**VALUE ENGINEERING CHANGE PROPOSAL
MISSOURI DEPARTMENT OF TRANSPORTATION**

Contract ID 091120-701 Job No. J7P2163
County ST. CLAIR 13 Original Bld Cost \$ 2,633,154.49
Contractor APAC-MISSOURI, INC. By DAVID B. TAG, P.E.
Designed By APAC-MISSOURI, INC. Phone (573) 449-0886
VECP# 10-16 (to be completed by C.O.) VECF or VECF/PDU

_____ Use exiting drop inlet in place in lieu of planned temporary construction.

Current design

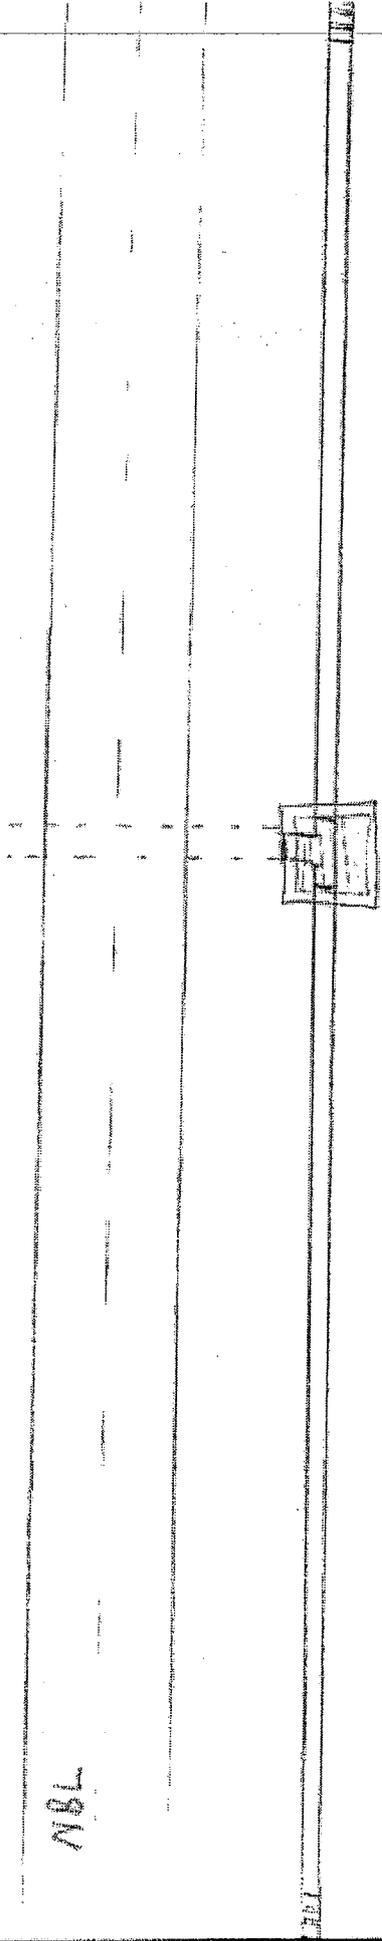
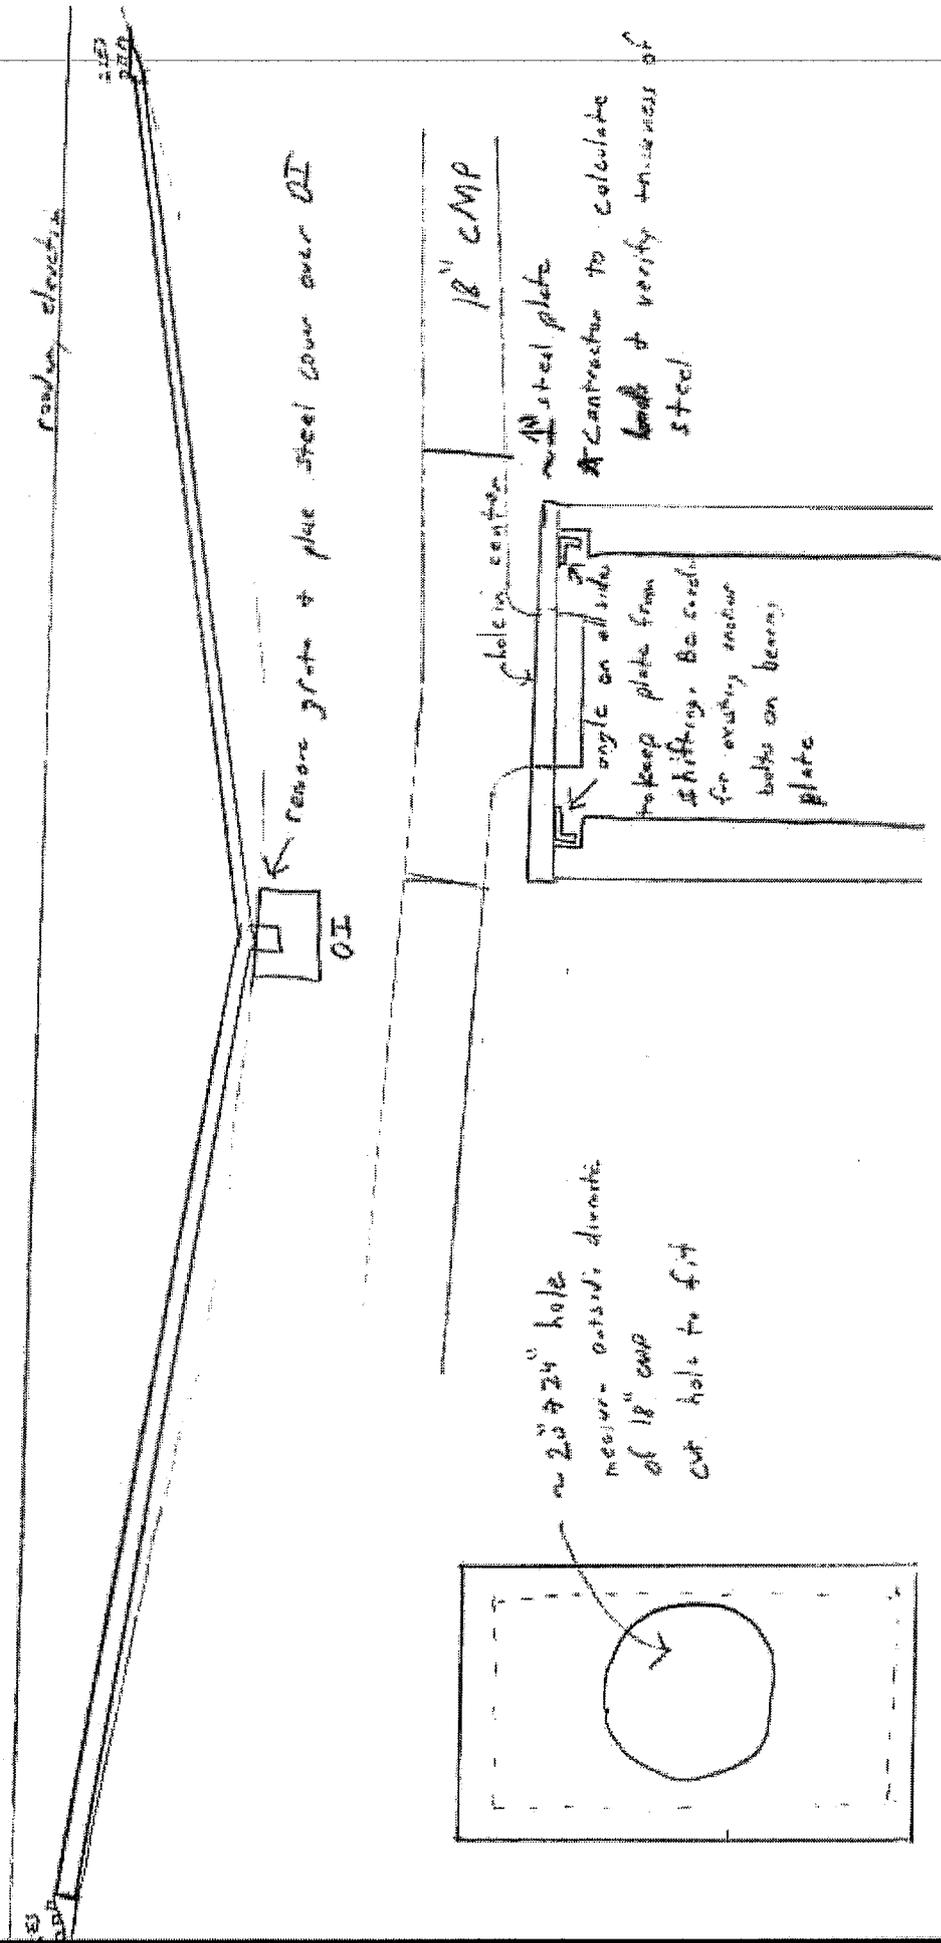
The current plan is to remove an existing drop inlet, connect the temporary drainage to the existing cross-road pipe with a tee, and after construction remove the temporary pipes and install a new drop inlet. This proposal is to use the existing drop inlet in place and connect the temporary drainage pipe with a tee through a steel plate fabricated in place of the grate and bearing plate. The advantages are reduced construction time, reduced construction cost, and using drainage in place that already exists. The disadvantages are decreased slope on the temporary drainage.

- 4" to tie into existing structure
- remove OI + saw grate
- replace OI with new one at end of b

Comments: After field review of this site, drainage concerns for this crossover are not expected to be an issue. No work will be required to improve the drainage. I do not recommend this proposal.

Comments: REJECTED PER DISTRICT RECOMMENDATION
ITEM OF WORK WAS FOUND TO BE UNNECESSARY
